CITY OF MENASHA
PLAN COMMISSION
Council Chambers
140 Main Street, Menasha

September 15, 2009

Community Development Department
Plan Commission Staff Report
September 15, 2009

Agenda Item II: Special Use Permit - Mission Village

SITE PLAN A
SCALE: 1"=30'–0"
1"= 30' SCALE 30' 0 30' 60' FEET

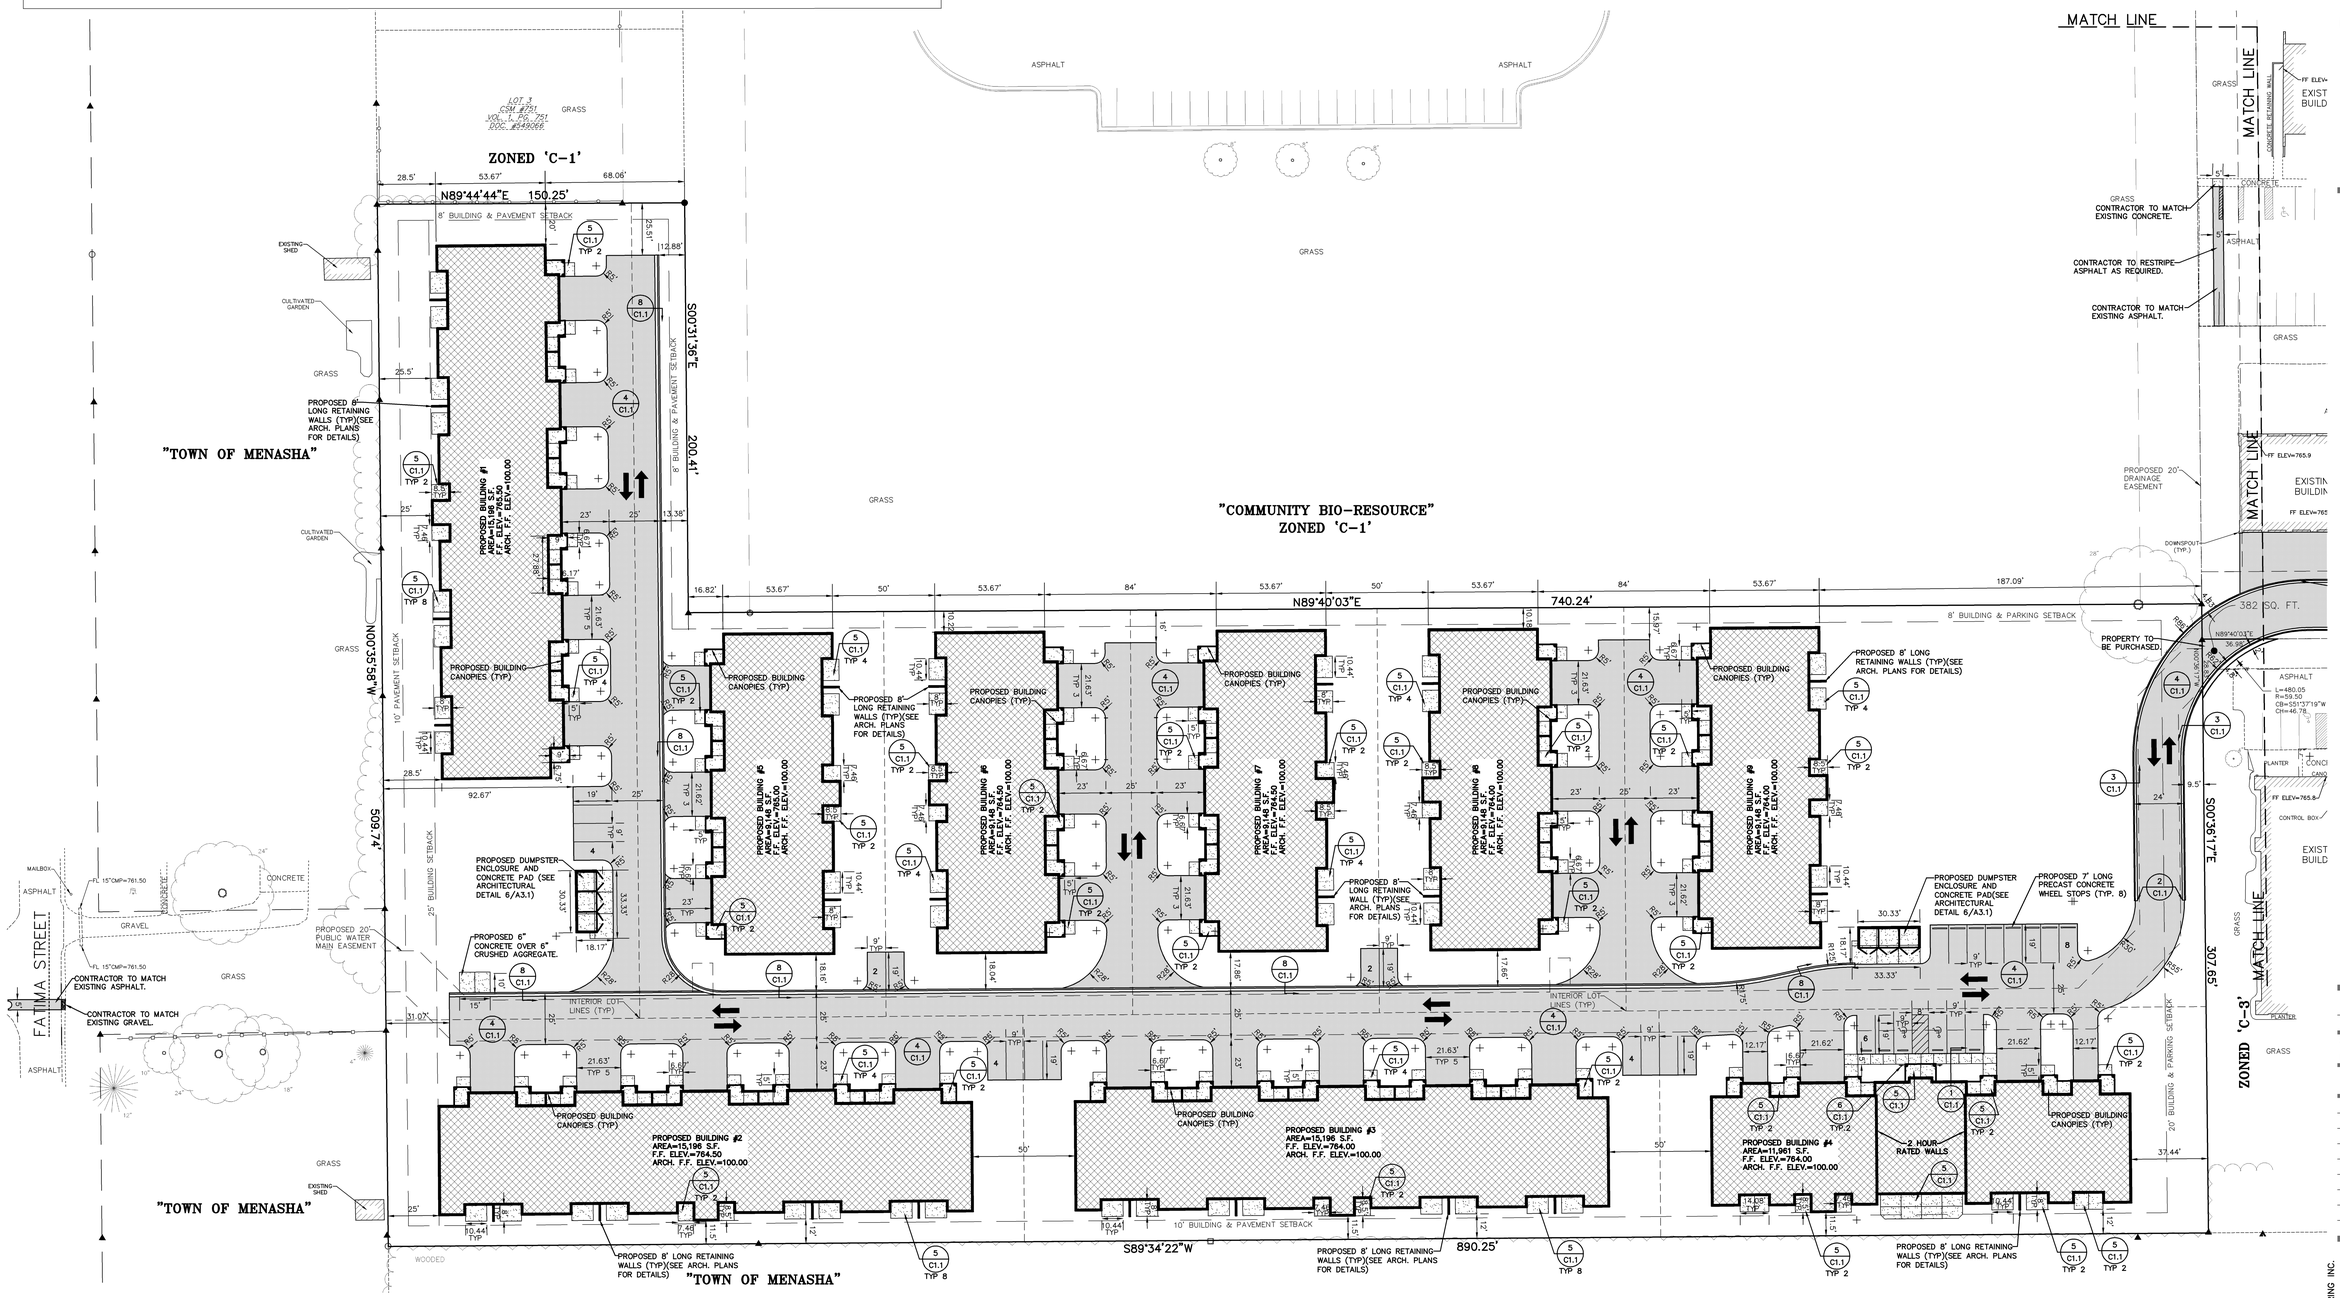
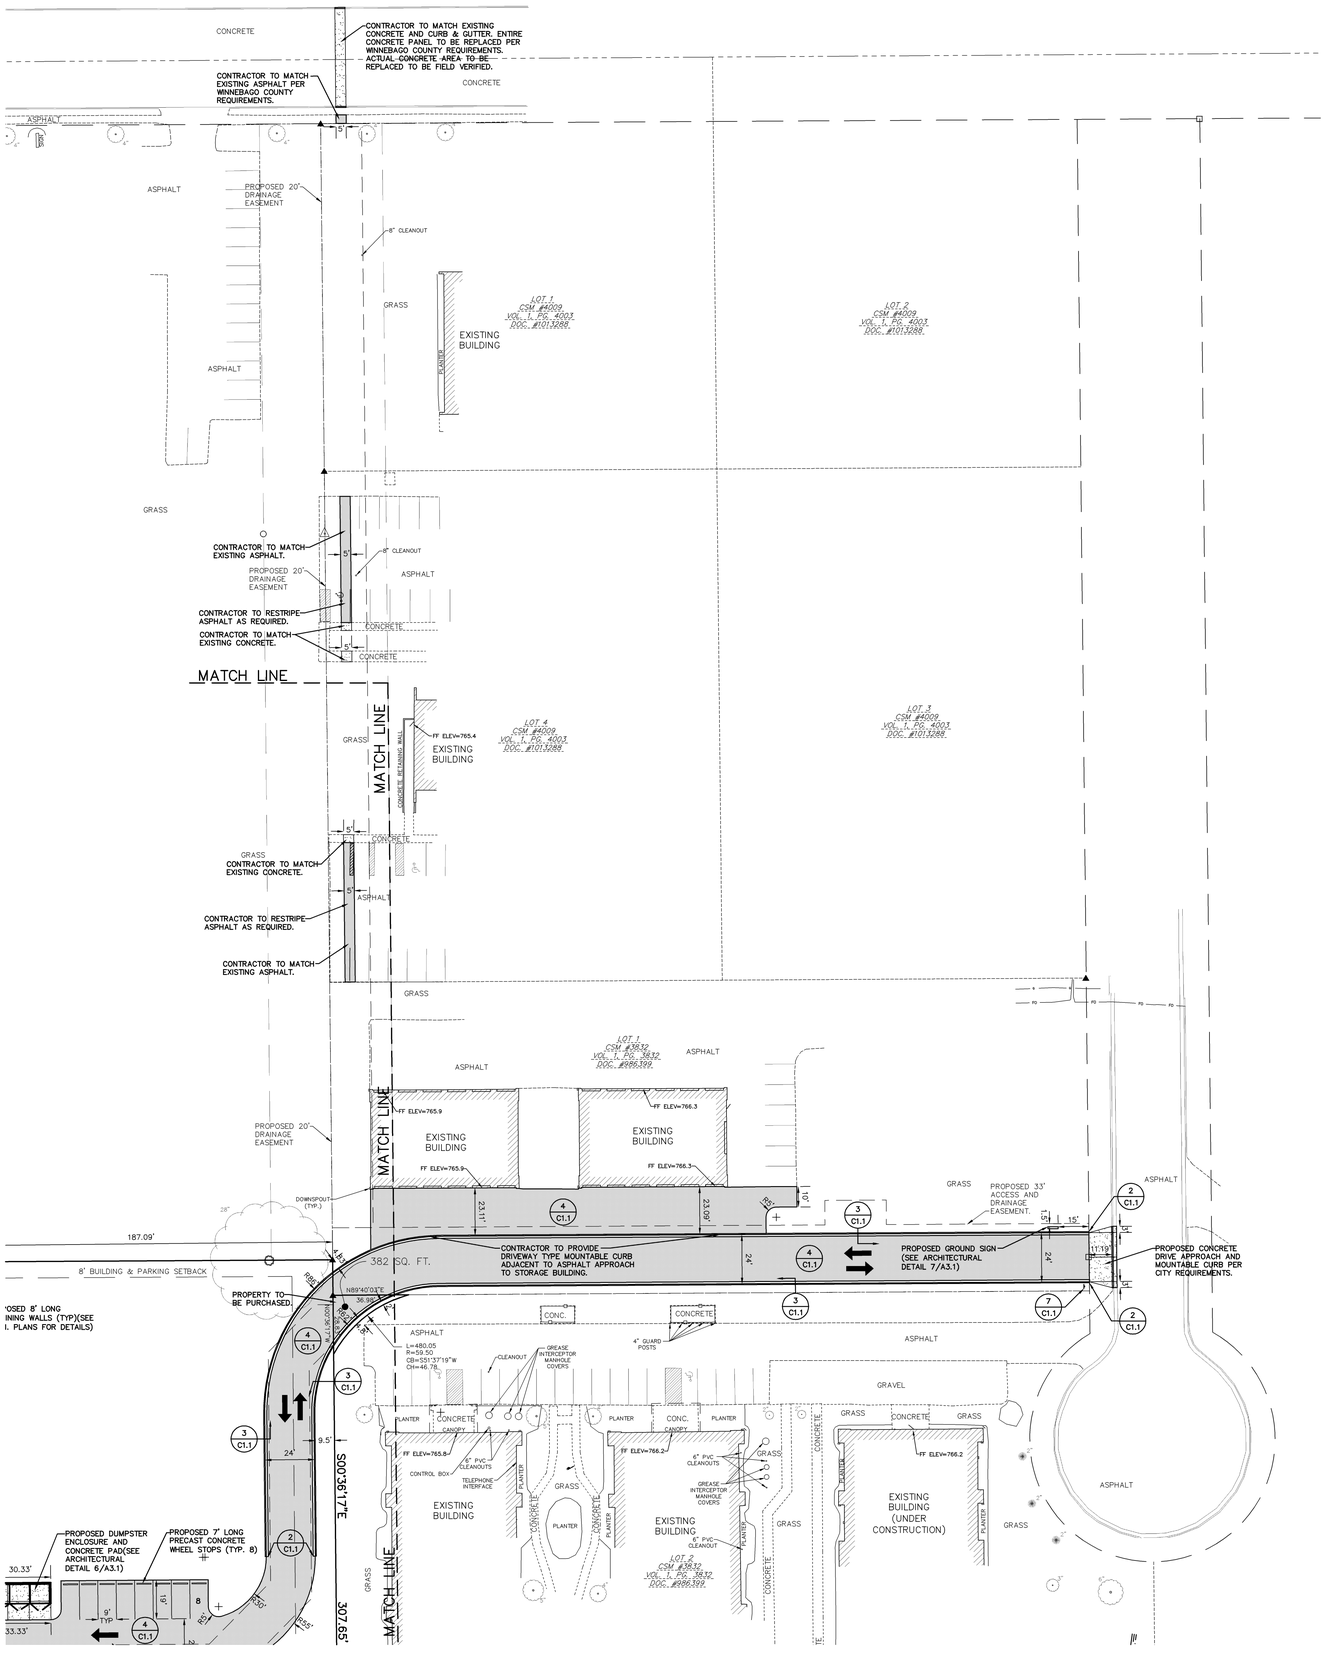
Access to the site has presented several challenges. Dedicated Town of Menasha ROW (Terrace Avenue) exists adjacent to the west property line; however, the town has been resistant to allowing access. Multiple options were explored, with the proposed layout onto Kenwood Drive presenting the most viable access point.

Parking consists of one garage and one driveway space per unit, plus 26 additional visitor parking stalls with 2 handicap stalls adjacent to the clubhouse. The number of stalls meets minimum requirements for the property use.

Staff also recommends the addition of a private walkway leading from the driveway to the property line adjacent to the dedicated Terrace Avenue ROW in the Town of Menasha to allow pedestrian access on the west side.

LANDSCAPE PLAN

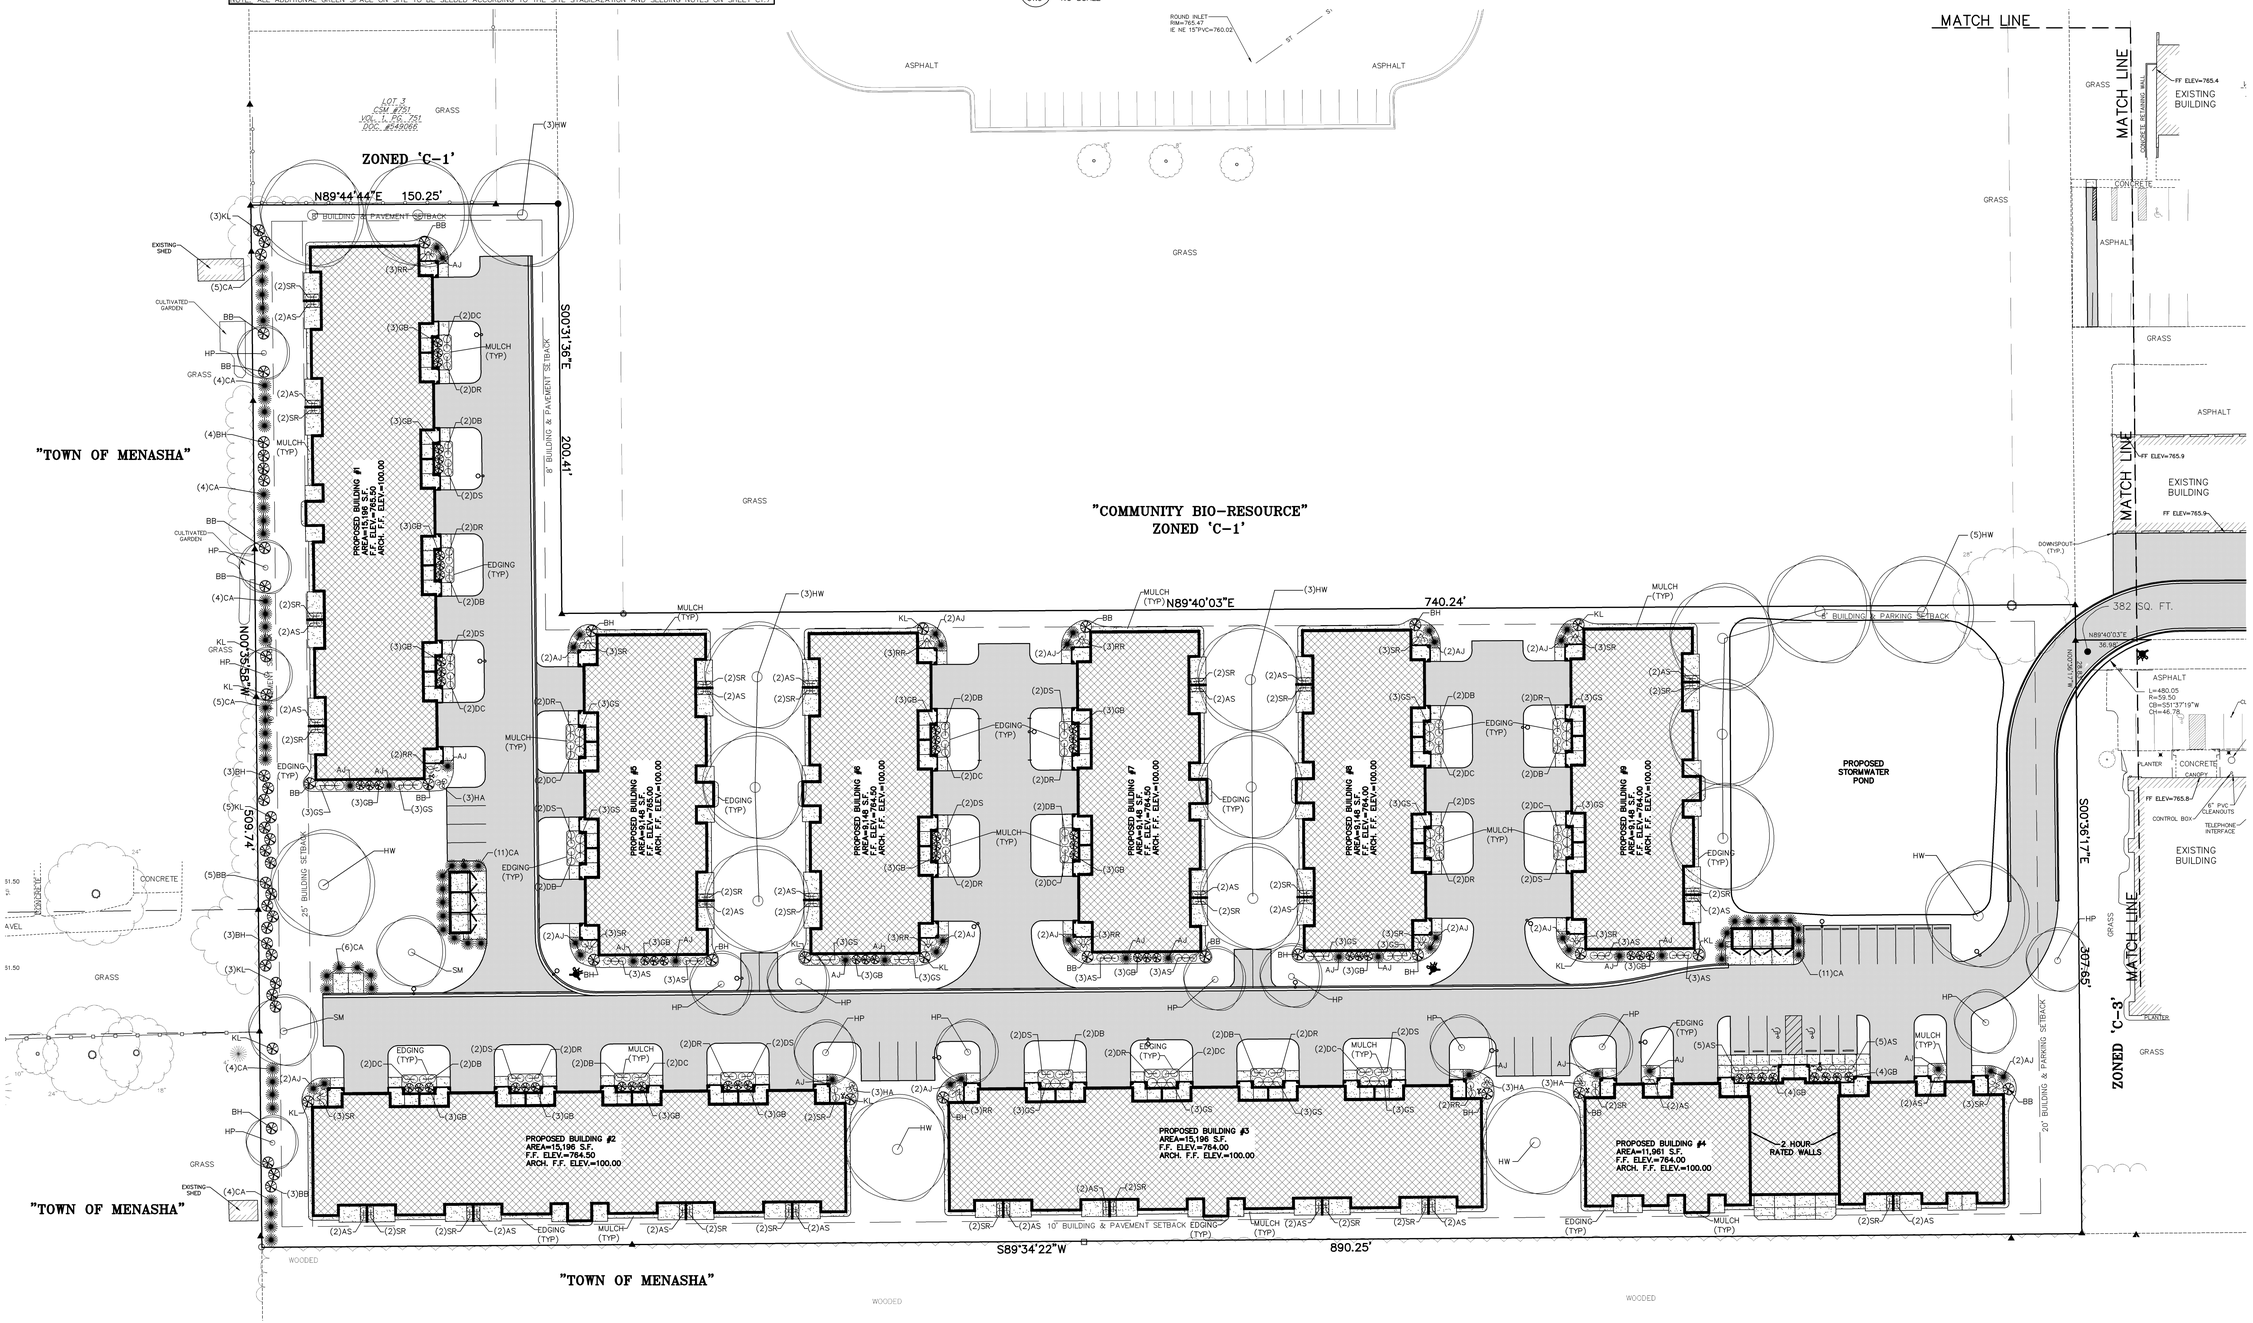
There are existing residential uses to the west of the site that normally would require a transitional area; however these properties are located in the Town of Menasha. The developer has provided a landscaped transitional area along the west boundary. The proposed transitional area does not meet our planting requirements for transitional areas; however it is the department's opinion that additional landscaping would be more effective located throughout the property. Dumpsters are enclosed and located on two different sites on the property. The lighting plan includes decorative street fixtures and meets ordinance requirements.

- an enhanced landscaping plan including the addition of a private walkway on west side of property;
- the full engineering plan, including grading, drainage, erosion control, and stormwater management.

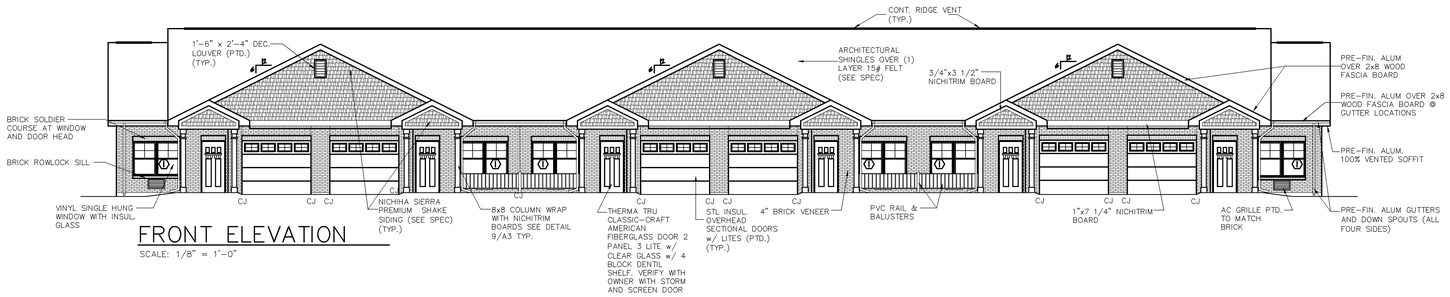
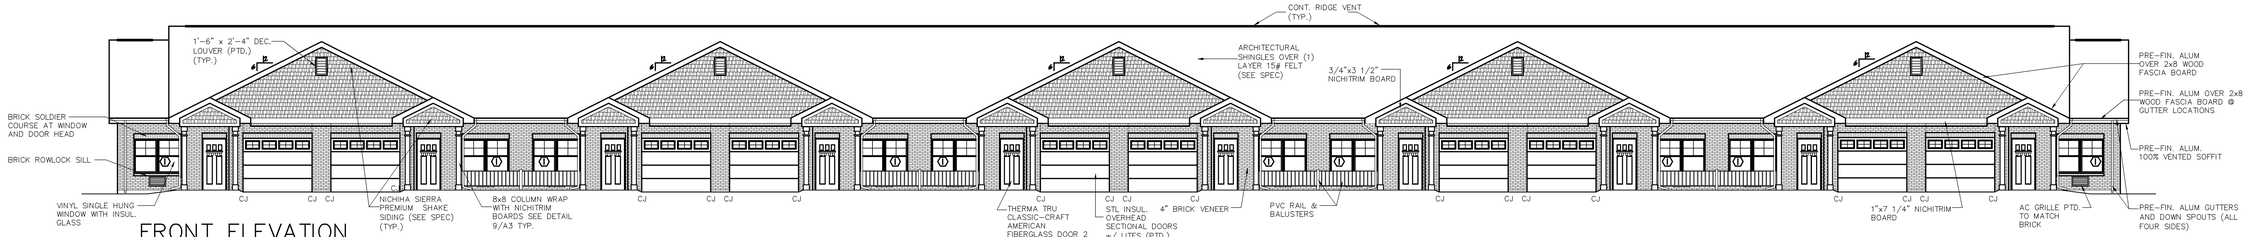
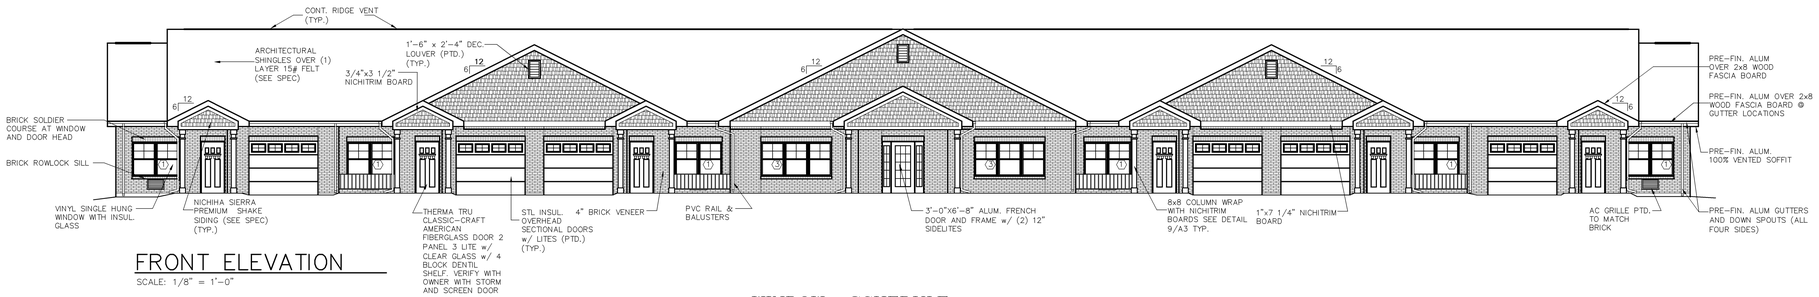
The developer is proposing nine buildings with brick masonry construction and secondary vinyl façade materials. Building elevations are enclosed for review and meet ordinance requirements.
